17/03755/REM

**Land Adjacent To 55 Down Ampney
Cirencester
Gloucestershire
GL7 5QW**

Erection of 2 dwellings with detached garages and associated infrastructure (Reserved Matters application) at Land Adjacent To 55 Down Ampney Cirencester Gloucestershire GL7 5QW

Approval of Reserved Matters 17/03755/REM	
Applicant:	
Agent:	Mr Duncan Lloyd Jones
Case Officer:	Martin Perks
Ward Member(s):	Councillor David Fowles
Committee Date:	13th December 2017
RECOMMENDATION:	PERMIT

Front Elevation (South West Elevation)

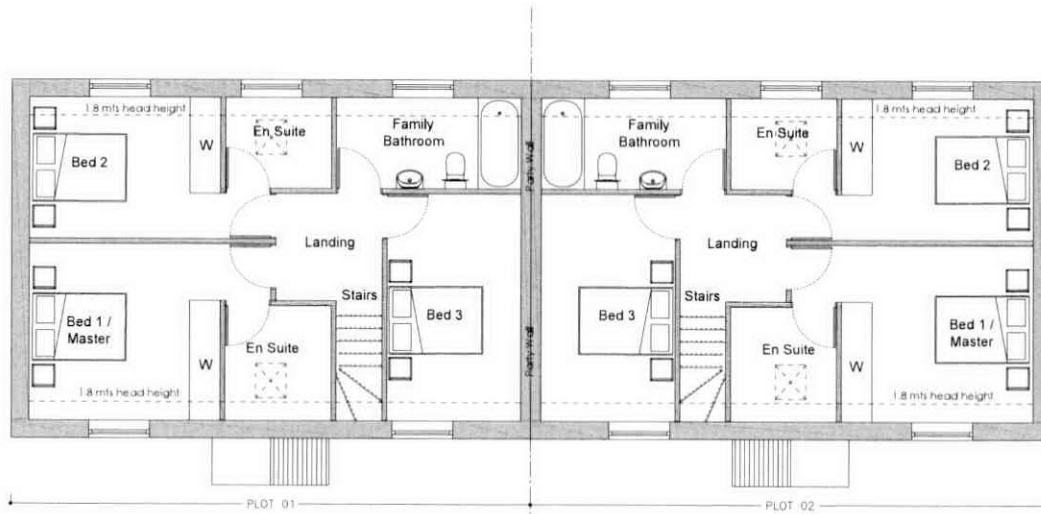
3. The roof lights are not in keeping with other similar 'estate' properties, and although we accept the windows are not ugly, their inclusion on the west side should be reconsidered.

4. The front door of the property should be set at the rear of the porch and not at the front of the porch to ensure it is consistent with other properties in Down Ampney and specifically with no 55, Down Ampney.

- i) Object to inclusion of rooflights in front elevation as they do not relate to the village vernacular and there are no similar examples on any road frontage in Down Ampney.

- ii) Object to the porchway front door being at the front rather than the rear of the porch as all cottages with porches have doors to the back of the porch.

- iii) Object to side windows in the proposed porch as there are no such windows in any porch in Down Ampney.
- iv) Object to the pitch of the roof of the proposed garages. Both 54 and 56 Down Ampney, when applying for planning consent for a garage were forced to accept different roof slopes so as to reduce height.

- vi) Two sky lights and a porch not in-keeping with the distinct vernacular of the village. I would ask you to reconsider these changes and make a decision which, despite these houses being, in my view, a blight on this part of the village, the impact is minimised as far as is possible by ensuring that they look integrated with current housing stock.

- vii) The major issue on this (to be) overdeveloped high profile site, given that permission has already been granted is the outrageous vernacular change in design. This pays no heed to the existing guidelines according to the Down Ampney Statement. The skylights on the front elevation are simply out of order given that not a single property in the village has any front facing skylight as far as I'm aware. Additionally, the lack of a 'porch'; a given feature throughout the village is an absurd attempt at gaining more footprint. As for the rear elevation I am simply lost for words. Are we now allowing the type of modern 'Swindon' look to invade our Cotswold villages. It is somewhat of a mess with too many windows, following no design course, seemingly randomly placed and of differing sizes.

- xiii) Neighbouring four properties have mullion window frames whilst the plan shows only stone lintels and cill to the front.
- xiv) Roof tiles are indicated as being of a red tone. The only red roof in Down Ampney has been completely re-tiled with grey tiles.

- ii) The current plans and elevations show the front door flush with the outside of the porch. The typical porch arrangement of this type of house nearby in the village has the front door set back to the main house line. This is what was indicated on the previous massing drawing in the outline planning permission.

In response to the comments of local residents, the applicant has agreed to remove the windows in the side elevations of the front porches. In addition, the single rooflights proposed for the front roofslope of each of the dwellings have also been amended to flush conservation style rooflights rather than standard rooflights which would protrude above the plane of the roofslope. In light of the modest size of the roofslopes, their flush appearance and their limited number it is considered that it would not be possible to sustain an objection to their introduction. The site is not located within a conservation area or an Area of Outstanding Natural Beauty and as such is not afforded the additional protection that accompanies development in such areas.

With regard to the position of the doors in the porches, it is of note that a couple of porches in the area (2 Down Ampney and 53 Down Ampney) have either a door or a window at the front of the porch rather than set back in line with the front elevation of the dwelling. The village design statement also has a section on porches. It does not mention that doors should be set back into the porch. Moreover, the porch illustrations in the design statement appear to show doors at the front of the porches. It is considered that it would not be possible to sustain an objection to the position of the porch doors as currently shown.

1414 P03d

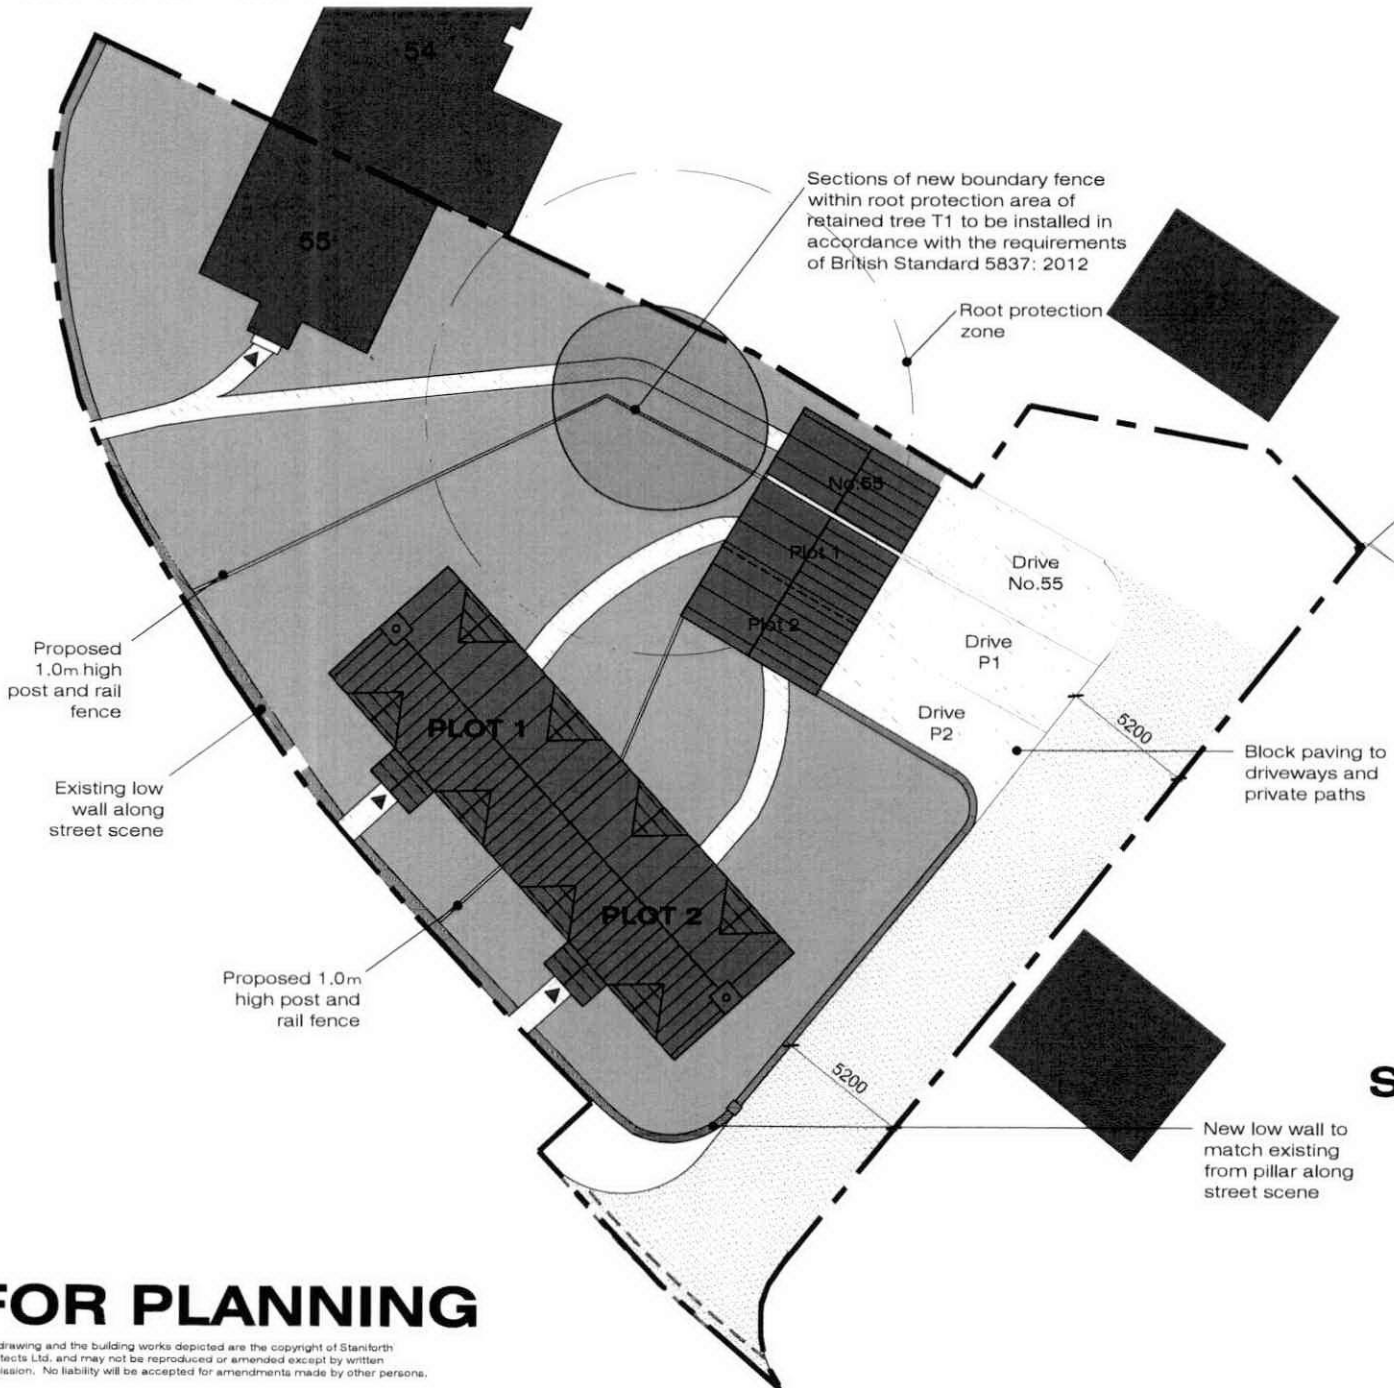
8. Further to this point we note that an amendment was made previously to the layout, which has involved widening the access track with the removal of one parking space. We oppose this change and would propose retaining the prior layout with a narrower access track and re-installing the additional parking space within the development.

- x) I believe the area available has insufficient space for two houses.
- xi) Insufficient parking space for more than one vehicle per household on site.

- xii) Increasing the drive width will reduce the sight line to main road. It will bring vehicles in near contact with edge of village green. Proposal will increase the traffic hazard for main road traffic entering a blind corner or Church Lane traffic entering the main road.

Vehicular access will also be via an existing driveway as approved by the Outline permission. The Outline permission requires the driveway to be widened from 3.5m to 5.2m to enable two cars to pass one another along the driveway. The driveway is currently shared with 54 Down Ampney. The widening of the driveway is considered to represent a betterment in terms of access. Two off street parking spaces will be provided for each of the proposed dwellings. Two off street parking spaces will also continue to be available for 55 Down Ampney.
